Building Permit Application

Permit No.: B14000590

Building Address: 12130 Hayland Farm Way
 City: Ellicott City State: Md Zip Code: 21042
 Suite/Apt. #: _____ SDP/WP/BA #: _____
 Census Tract: _____ Subdivision: Walnut Creek
 Section: _____ Area: 33,000 Lot: 28
 Tax Map: 28 Parcel: 49 Grid: 17418
 Zoning: _____ Map Coordinates: _____ Lot Size: 33,000

PERMIT SITE PLAN
LOT 28
 12130 HAYLAND FARM WAY
WALNUT CREEK

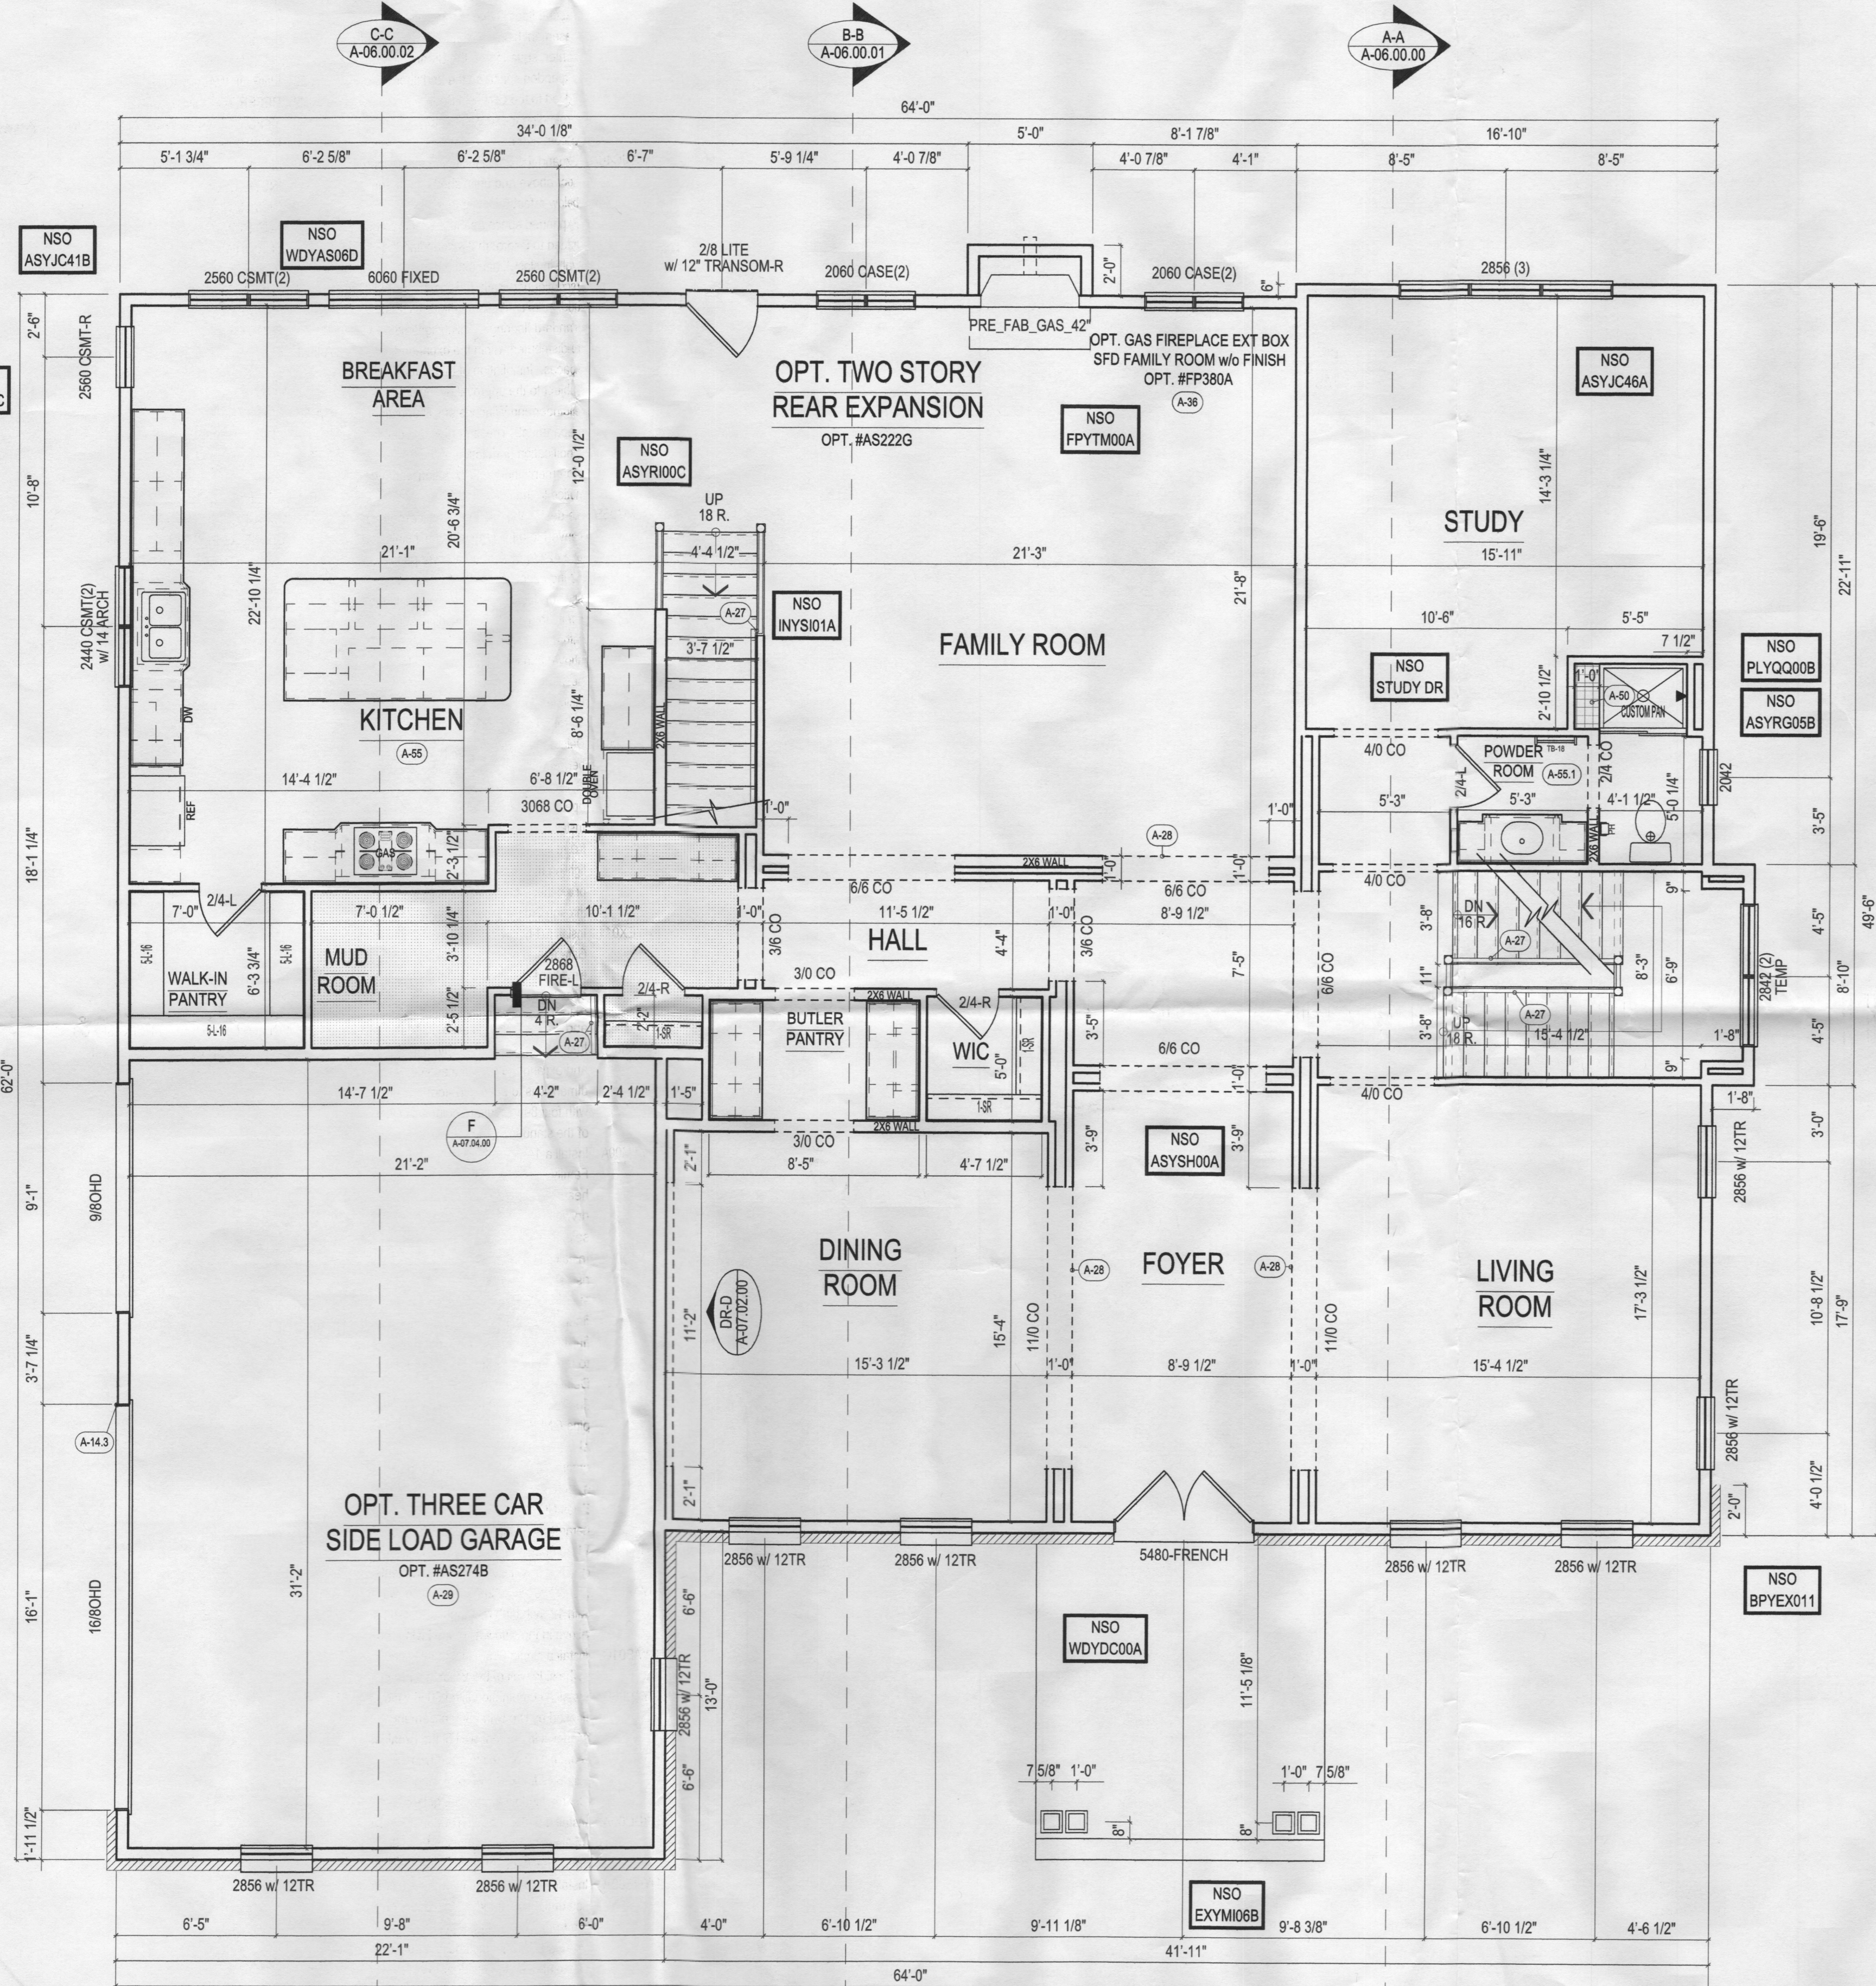
I'll take a look at them. The issue with both had to do with confusion over the sight plan whether the 1st floor optional full bath was chosen on either. I suppose you are saying that on lot 25 they had chosen that option, but on lot 28 they did not? If so, lot 28 would have the 4 bedrooms up and 1 in basement making 5 total.

NOTE:
 FIRST FLOOR SEWER
 SERVICE ONLY
 BASEMENT WILL NOT
 SEWER BY GRAVITY

FIRST FLOOR PLAN

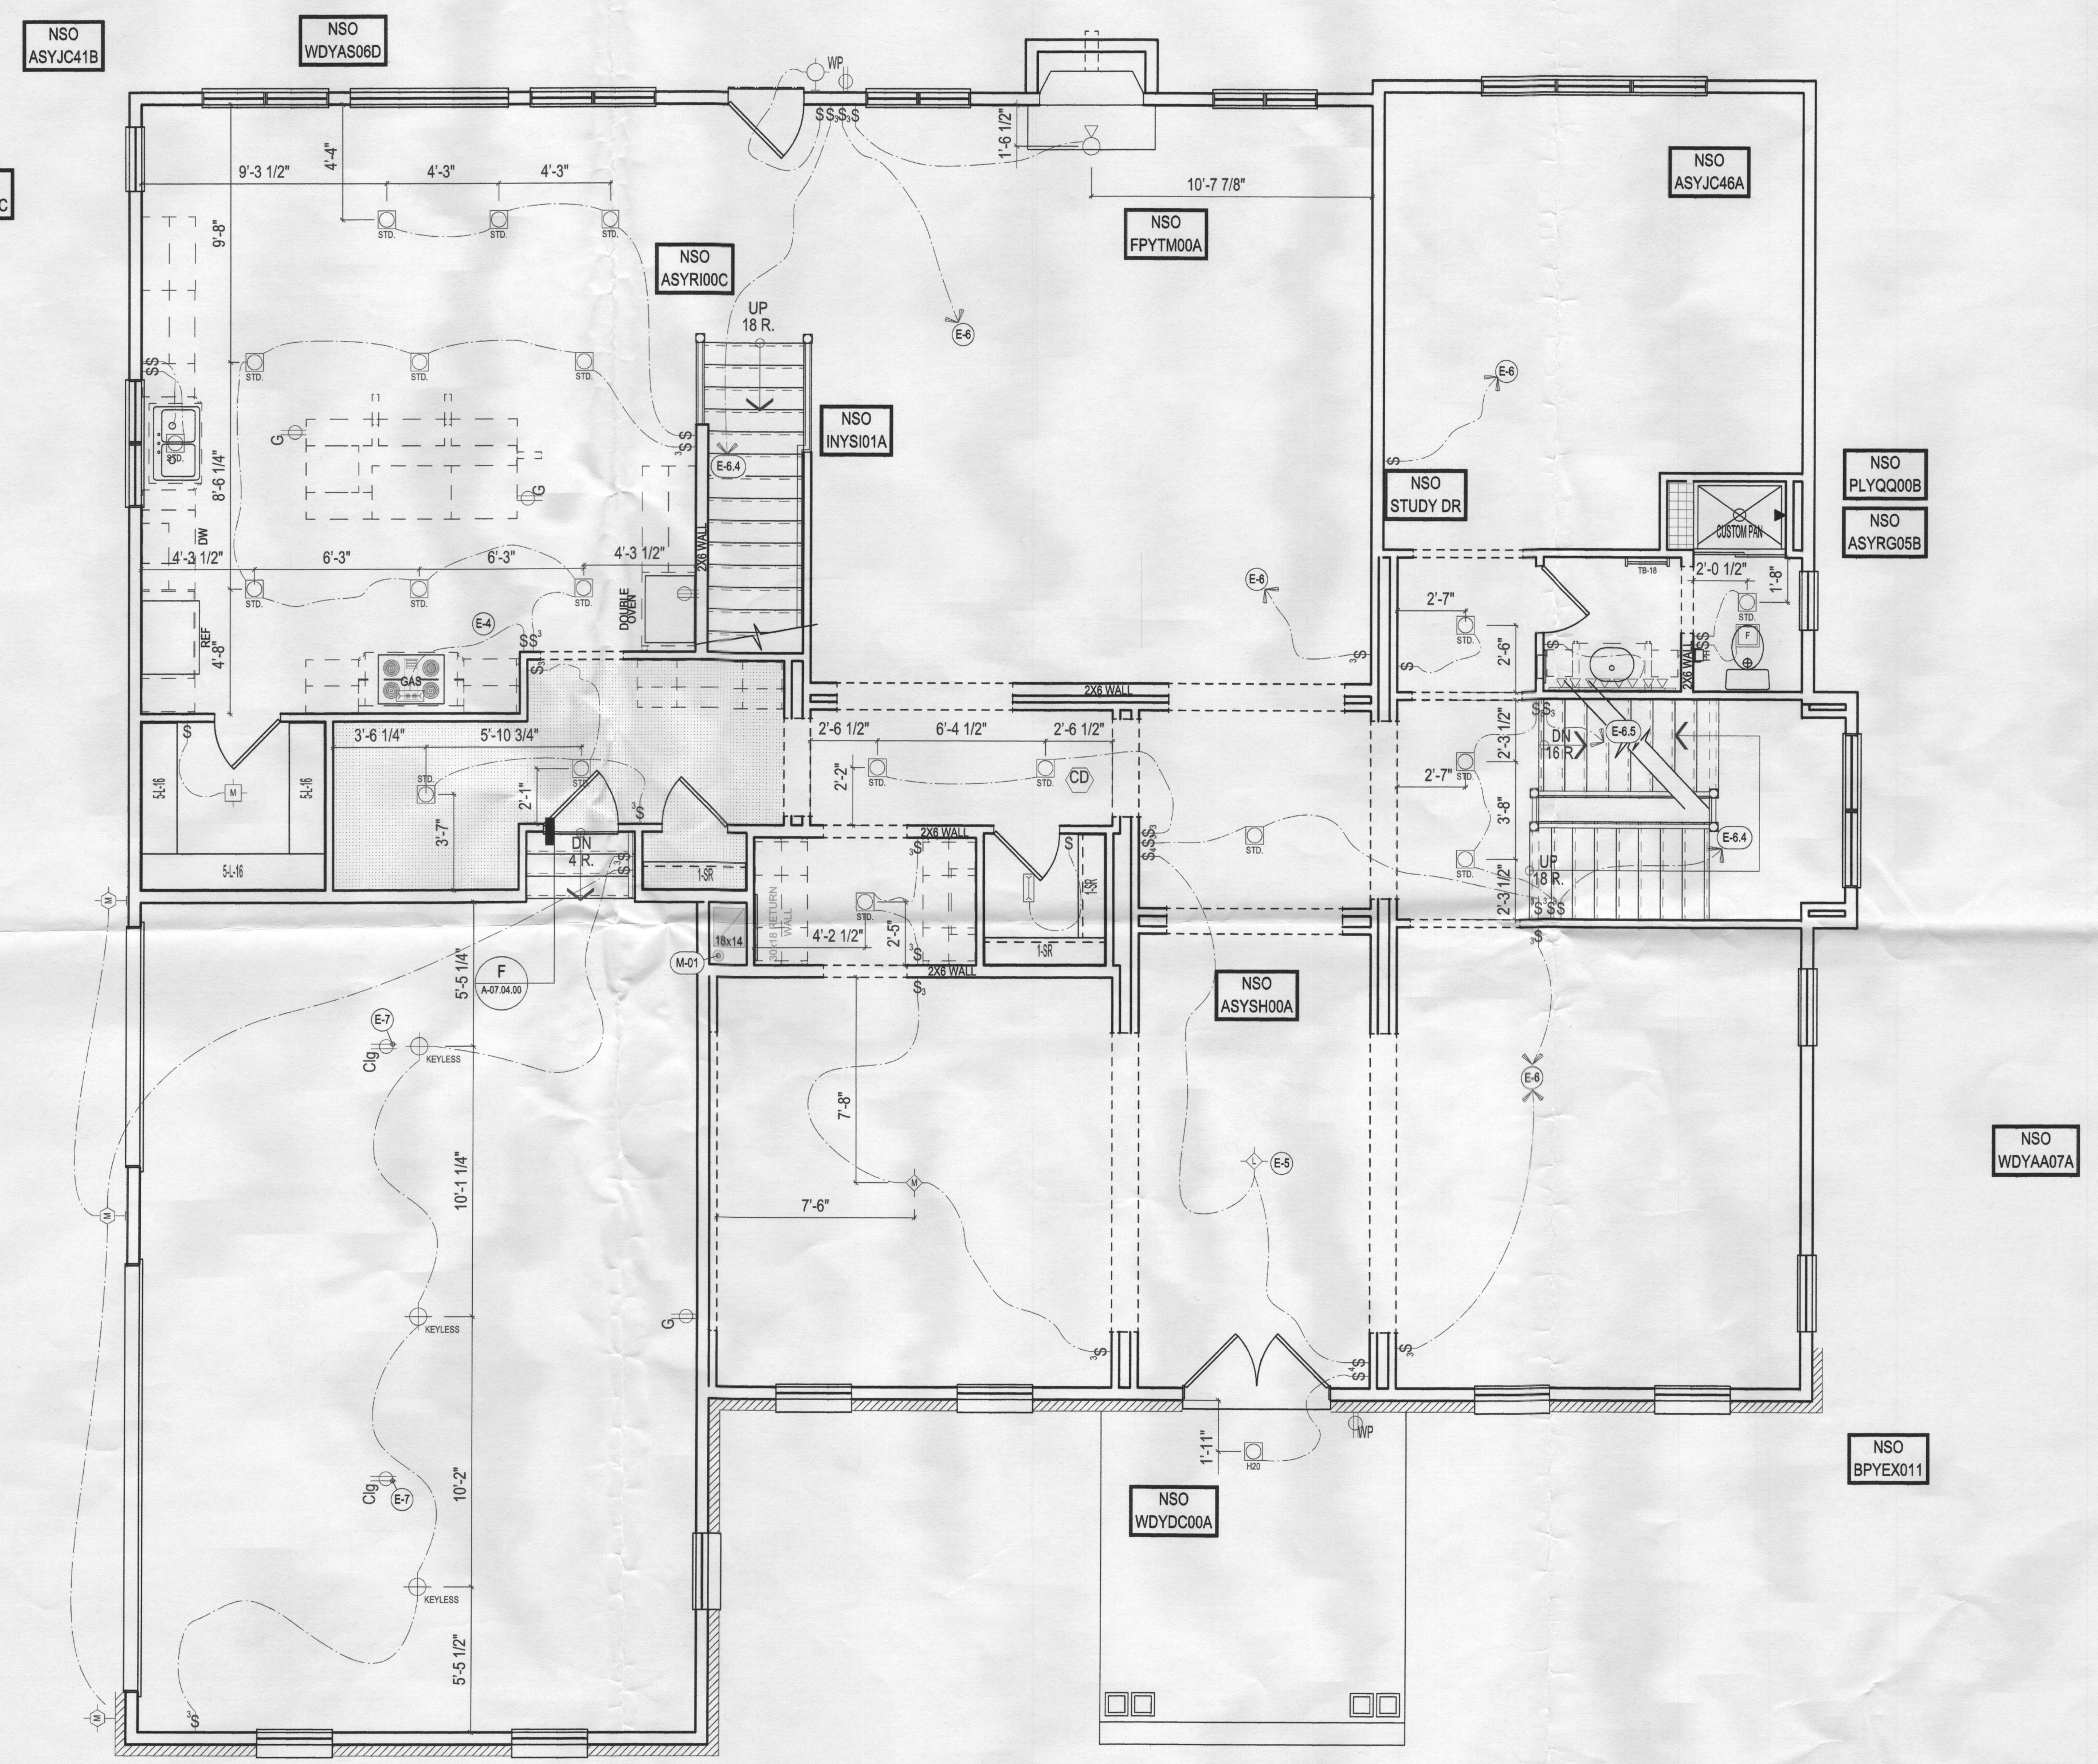
We would consider that study a bedroom. The closet is not the determining factor for defining a bedroom in our code. The bathroom access in that case is something we would call direct. It is right outside the room. You could do the doorway fix on either room in order to keep the bathrooms as-is

Correct me if I'm looking at the wrong plans for 28, but I am looking at a den in the basement next to a full bath for 1 bedroom, a study on the 1st floor next to a full bath for bedroom 2, and 4 bedrooms upstairs making 6 total. – The study on the first level does not contain a closet. This may be the confusion. We were under the impression that since it did not have a closet it and the room was not connected directly with the bathroom this was not considered a bedroom.

Refer to the email I just sent regarding lot 25. This lot also has 6 bedrooms counting the den in the basement and the study on the 1st floor. Please revise in similar fashion. Thanks.

STUDY DR Make opening into study a 4/0 Cased opening to satisfy county requirements.
